TECHNICAL BULLETIN

[Issue No.] GOT-A-0101-C

[Title] Withdrawal of the ATEX Directive and KCs Certification for the GOT2000 Series

[Relevant Models] GOT2000 Series

3.1 Rating plate

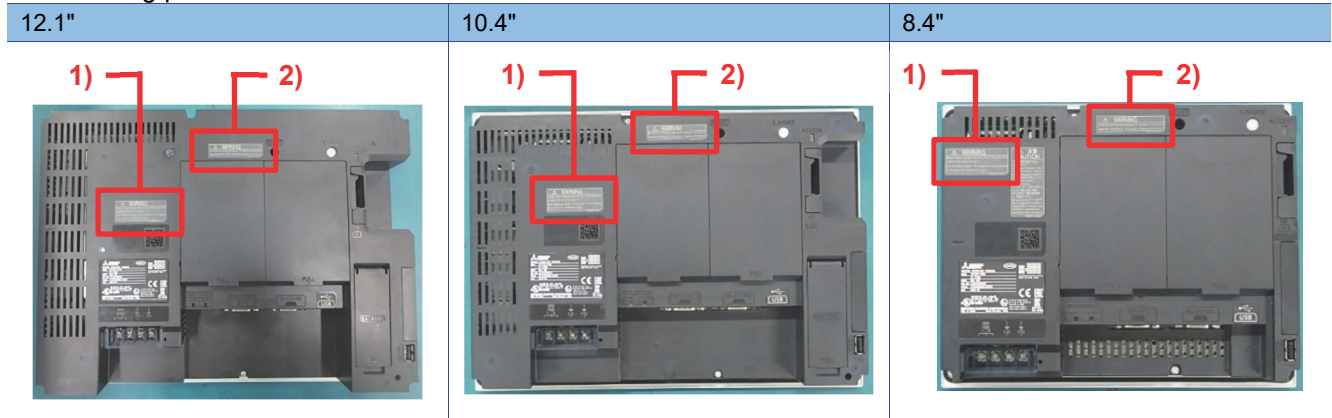
The ATEX Directive mark and KCs mark will be removed.

Items to be removed

3.2 Warning plates

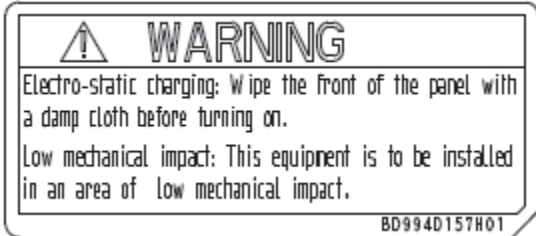
Two warning plates will be removed.

1) The warning plate about static electricity and low mechanical impact will be removed.

2) The warning plate about the restrictions on the extension interface will be removed.
